REMARKS

AMENDMENT UNDER 37 C.F.R. § 1.111
U.S. Appln. No.: 10/542,576

Attorney Docket No.: Q89211

FIG. 11

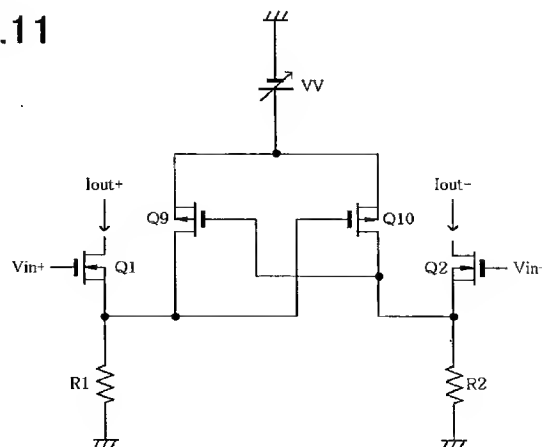
The Examiner has objected to the drawings as allegedly failing to show wherein the active device carrying out voltage-current conversion and the active device comprising a negative resistance device are comprised of the same type of transistors *having electrical conductivities different from each other*, as recited in amended claim 19.

Applicant directs the Examiner's attention to FIG. 11 of the present application, reproduced below, which illustrates "the same type of transistors having electrical conductivities different from each other," as recited in claim 19.

FIG. 11 discloses p-type and n-type metal-oxide-semiconductors (PMOS and NMOS) which are transistors of the same type having electrical conductivities different from each other. The NMOS active device (Q1) carries out voltage-current conversion and the PMOS active device (Q9) comprises the negative resistance device.

Accordingly, Applicant respectfully submits that the drawings illustrate "the same type of transistors having electrical conductivities different from each other" as claimed, and respectfully requests that this objection be withdrawn.
